**SANTA CLARA/SANTA CRUZ COUNTIES
AIRPORT/COMMUNITY ROUNDTABLE**

March 6, 2020

Subject: PIRAT follow up questions for the FAA

The SCSC Roundtable is submitting the following four requests regarding the PIRAT TWO Standard Terminal Arrival Route (PIRAT TWO STAR) for the FAA's review and response:

Figure 4. Pacific 2 Tailored Arrival and the Proposed PIRAT STAR

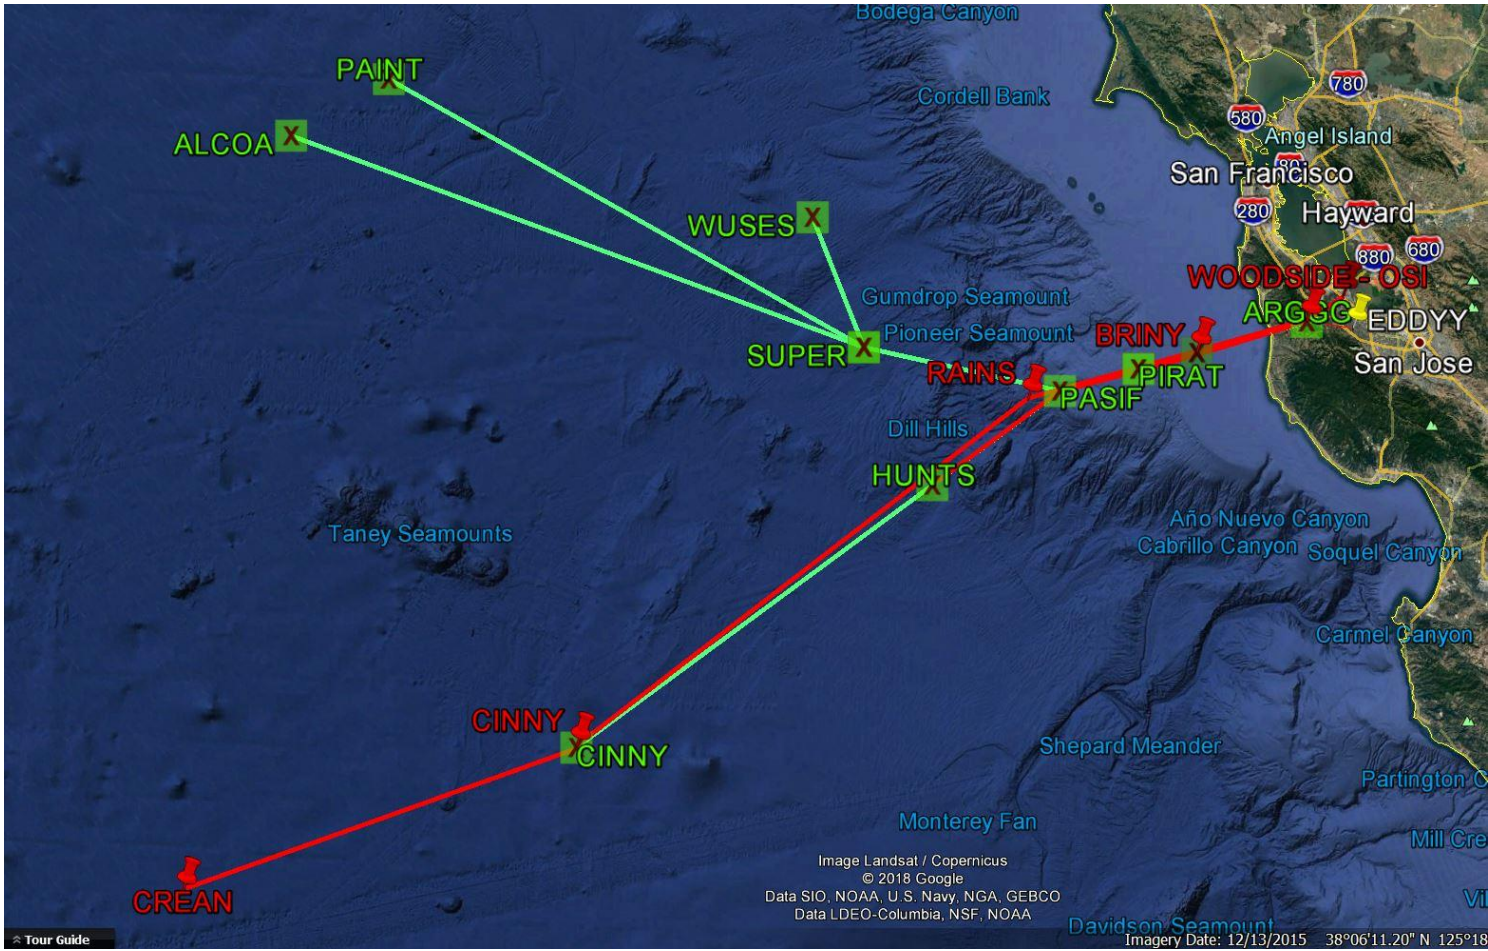
Assumption 1 – The FAA noted, "an increase in operations is not expected". (Page 17, the CATEX). Slide 18 of the 2/26/2020 FAA presentation to the SCSC RT (or page 30 of the meeting packet) shows a 35.5% increase from 2018-2019, 4044 to 5579, May through August. Note: many Oceanic arrivals are nighttime flights.

Note that Joseph Bert, from the FAA, commented on the increased usage of PIRAT at the 2/26/2020 meeting: he stated, “the PIRAT has increased, which is kind of, I guess, anticipated when you don’t have a STAR and then you bring in a STAR. People are going to want to fly the STAR” (see time stamp 53:46 of the [video of the 2/26/2020 SCSC RT meeting](#)). Such statement is in direct contradiction with the CATEX assumption that usage would not increase.

Assumption 2 – The FAA denotes the project as a “Community Request”. (Page 22, the CATEX)

Note: The PIRAT procedure was not requested by the Community. What was created by the FAA was different from what was asked for. By implementing the PIRAT STAR, there is an increased volume of planes AND these aircraft produce a higher level of noise before final approach because they need to lose altitude faster than the former procedure. Furthermore, a limited-use (Tailored Arrival) procedure was converted to a public-use navigation (RNAV STAR) procedure for both SFO and OAK arrivals.
